Suzuki Samurai Tailgater Storage Bin with Optional Lockable Lid (SKU# SIB-TGOLL)

Technical Service Bulletin

Item 1

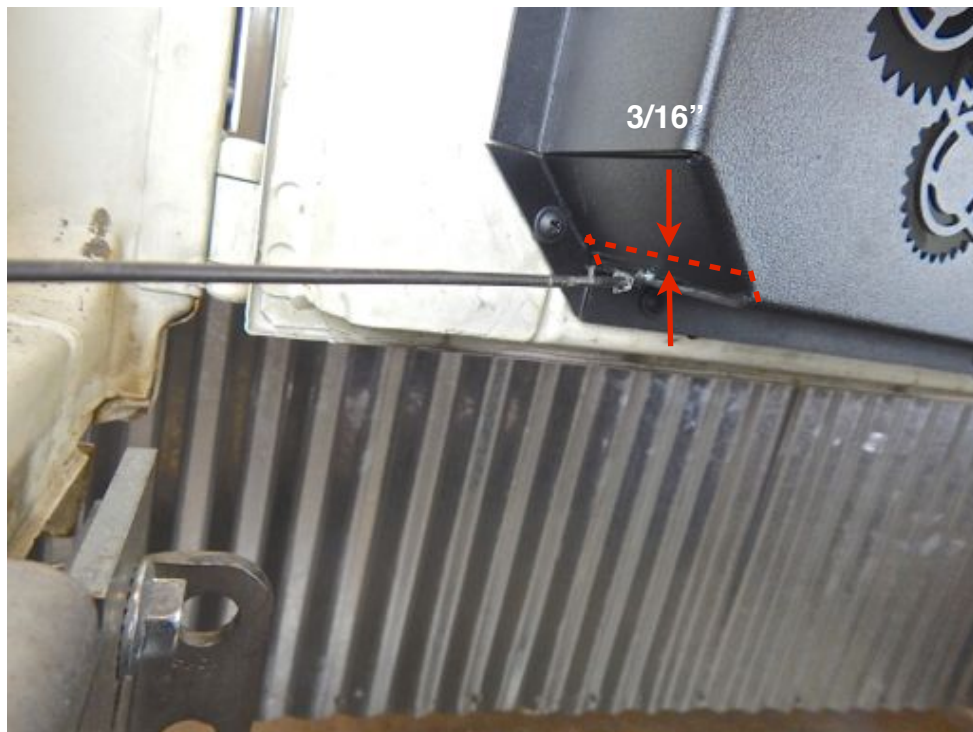
Our current Tailgater design does not accommodate the OEM tail gate restraint cable. If you would like to keep the OEM restraint cable, here is one solution. See Item 2

Using a cut-off wheel Air Saw or Dremel® tool, enlarge the opening 3/16" as shown here. This job could be easier if the Tailgater was removed. Be sure to remove any burrs so the cable is not damaged over time due to rubbing. Additionally, you may want to put a little black paint on the exposed metal to reduce the risk of rust. The OEM cable will pass through this opening and work just fine.

Note: Our next generation of the "Tailgater" will have this wider gap already designed in it.
